## **Product Change Notice (PCN)**

PCN Number: PCN-0455137R-01

Product(s) Affected: PJ-059AH

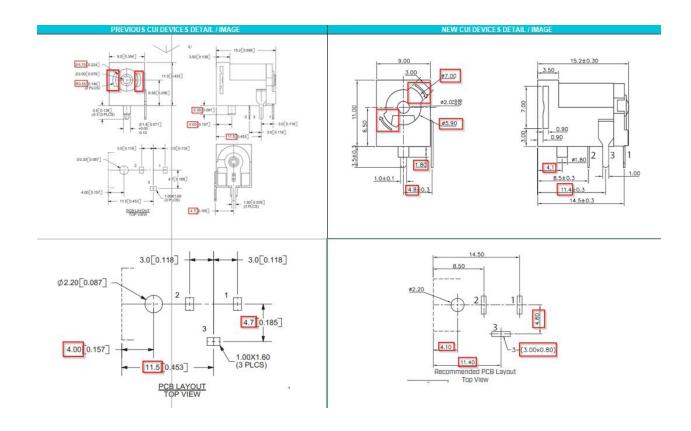
Description of Change: Minor Housing and footprint differences. Material Change on the housing and terminals. See image Below

MATERIAL	PLATING
center pin	copper	nickel
terminal 1	brass	silver
terminal 2	copper alloy	silver
terminal 3	brass	silver
plastic	PBT

DESCRIPTION	MATERIAL	PLATING/COLOR	
center pin	brass	nickel	
terminal 1	brass t=0.30	silver	
terminal 2	bronze t=0.25	silver	
terminal 3	brass t=0.30	silver	
cover	PBT (UL94V-0)	black	
housing	PBT (UL94V-0)	black
